CITY OF ALBUQUERQUE

**RE: 7201 Montgomery Blvd NE Church of Christ
Grading Plan Engineer's Stamp Date: 12/07/2018
Hydrology File: F19D003A**

Based upon the information provided in your submittal received 12/07/2018, the Grading and Drainage Plan cannot be approved for SO-19, Building Permit, or Grading Permit until the following conditions are addressed.

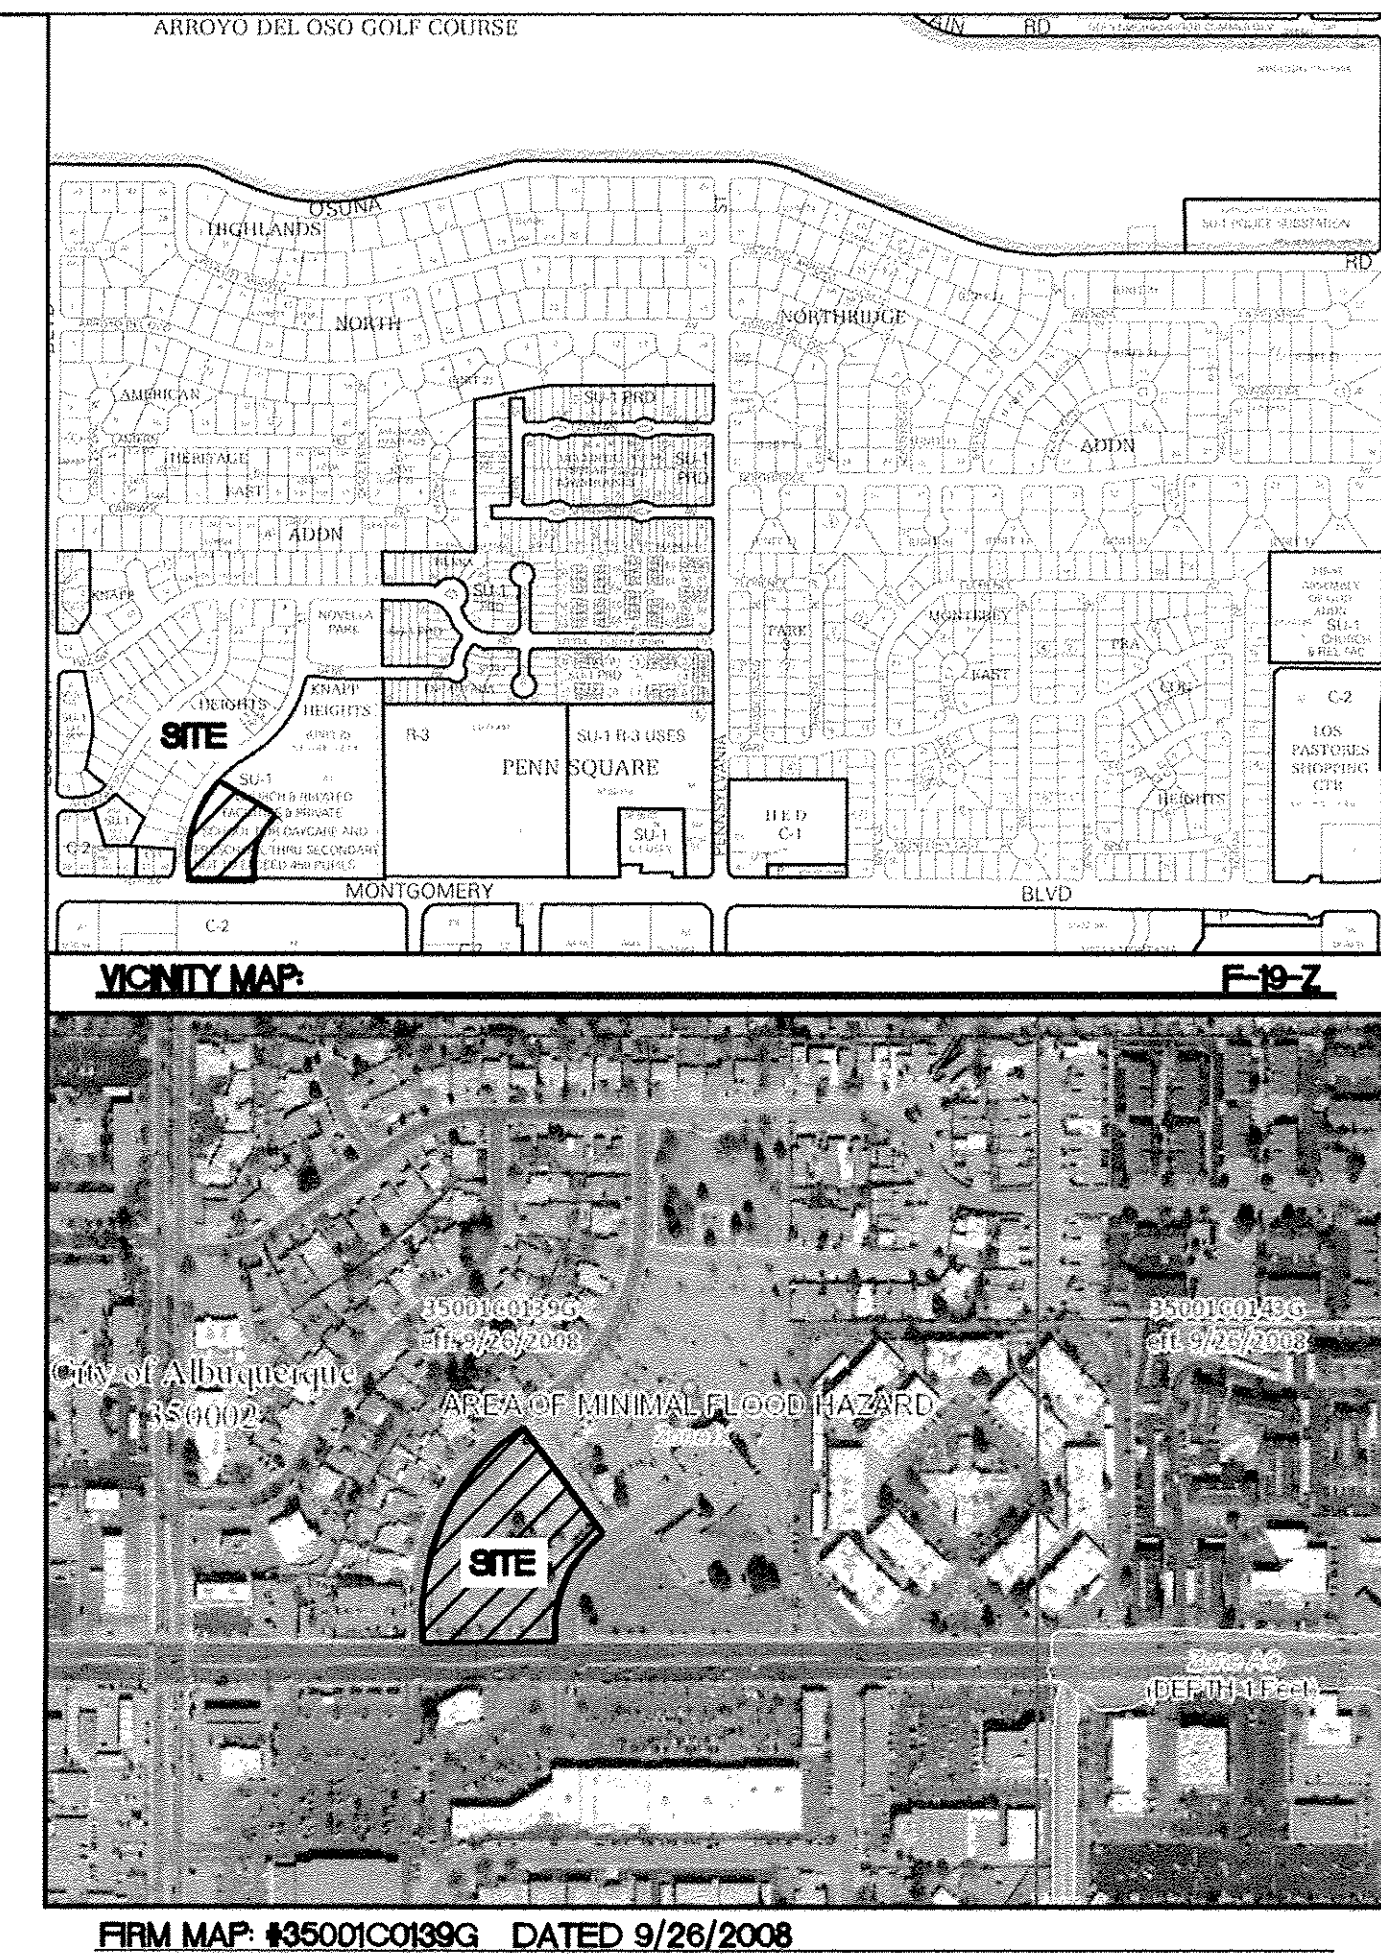
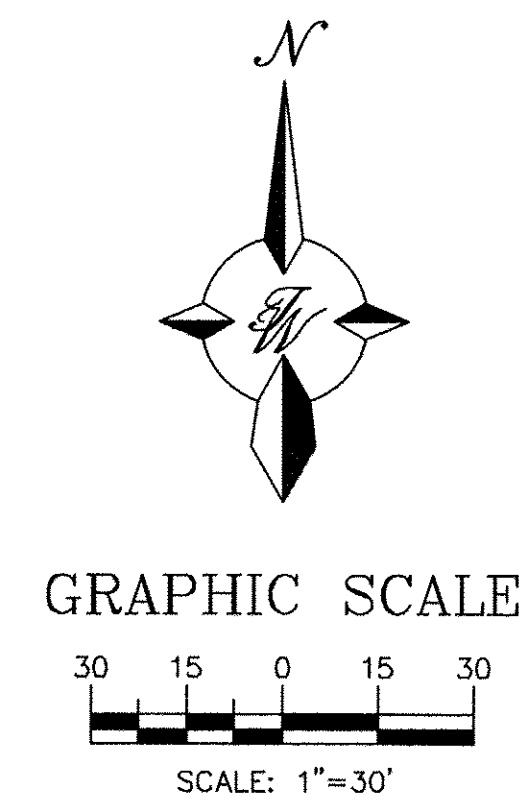
5. The water quality precipitation depth in the calculations on the plan (Sheet C-2) needs to match the depth in the report, 0.26" for re-development.
6. As a reminder, if the project total area of disturbance (including the staging area and any work within the adjacent Right-of-Way) is 1 acre or more, then an Erosion and Sediment Control (ESC) Plan and Owner's certified Notice of Intent (NOI) is required to be submitted to the Stormwater Quality Engineer (Curtis Cherne, PE, ccherne@cabq.gov, 924-3420) 14 days prior to any earth disturbance.

ENGINEER'S SEAL	MONTGOMERY CHURCH OF CHRIST 7201 MONTGOMERY BLVD. NE	DRAWN BY BF
	GRADING PLAN	DATE 12/7/18
	TERRA WEST, LLC 5571 MIDWAY PARK PLACE NE ALBUQUERQUE, NM 87109 (505) 858-3100 www.tierrowestllc.com	2016037_GRB
RONALD R. BOHANNON P.E. #7868		SHEET # C3
		JOB # 2016037

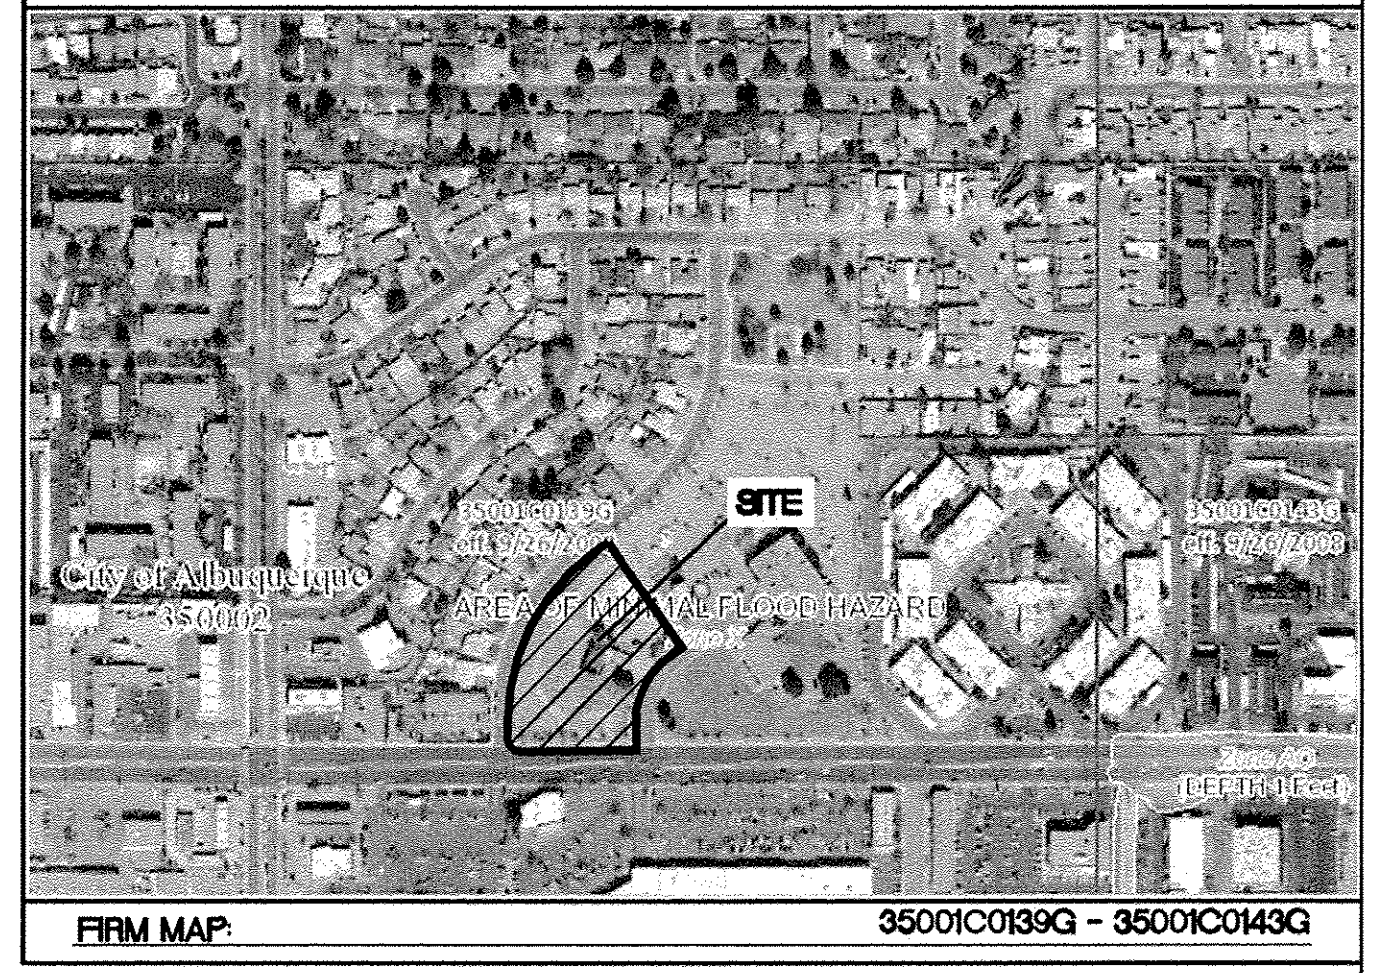
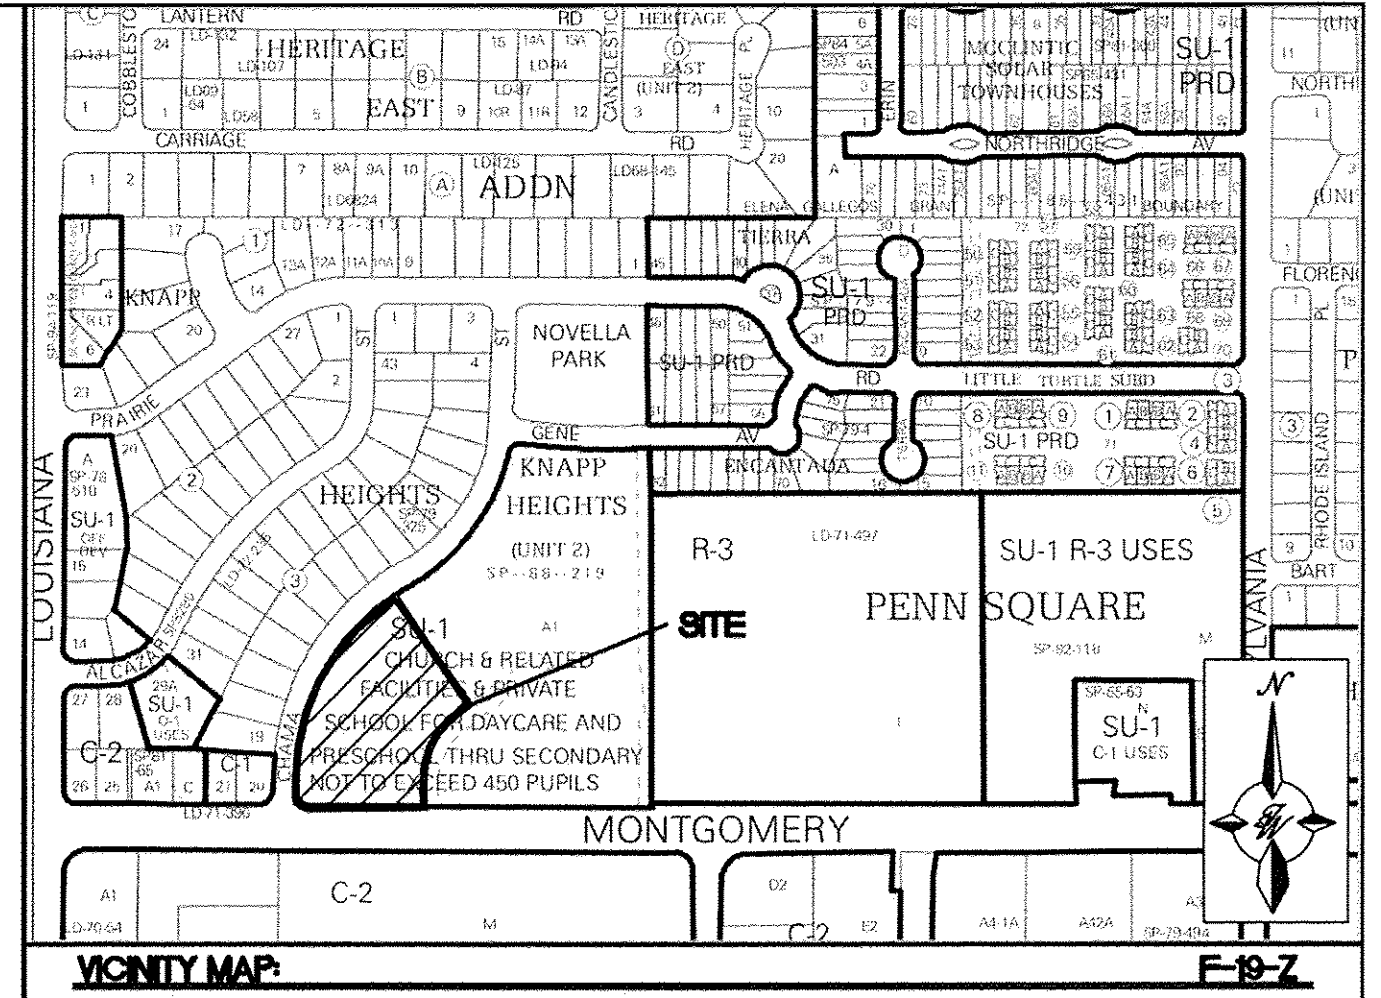
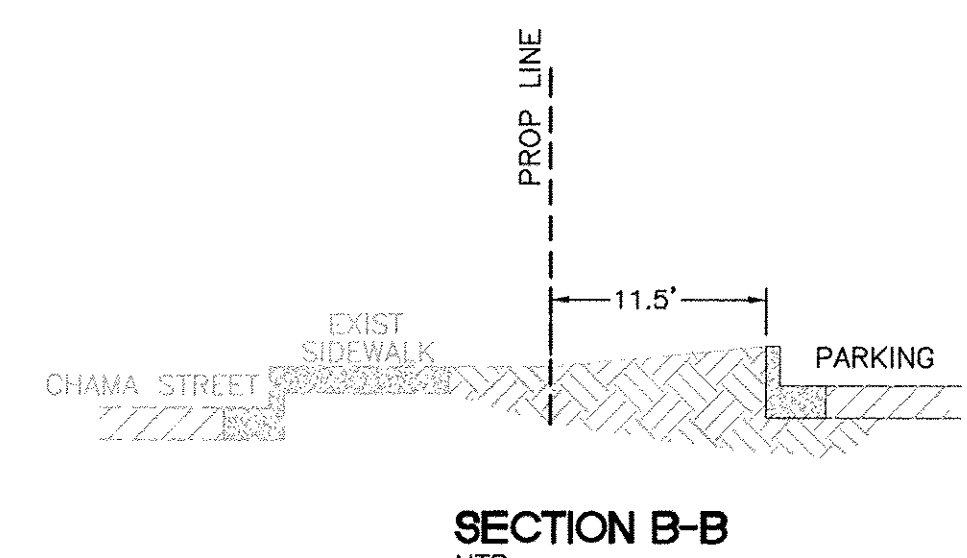
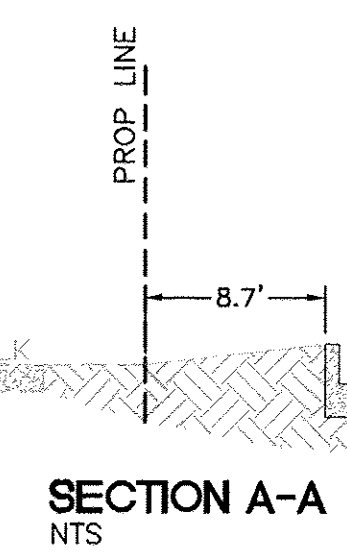
1. Add standard SO-19 notes available on the hydrology web page.
2. There are two sets of contours inside the ponds making the plan hard to read. Please revise so the pond contours are legible.

3. The drainage rundowns into the ponds and the sidewalk culverts need to be sized using both the weir equation and normal depth, whichever is the more limiting. At 8" depth they have capacity for about 1.25 cfs per foot width. The width of the rundowns and the sidewalk culverts needs to be increased to provide 100 year capacity.

4. Please provide normal depth calculations for sizing the curb height in the parking lot. Curb heights in the parking lot should be specified on the plan and curb with gutter recommended where the parking lot curb is used to collect and convey the drainage.
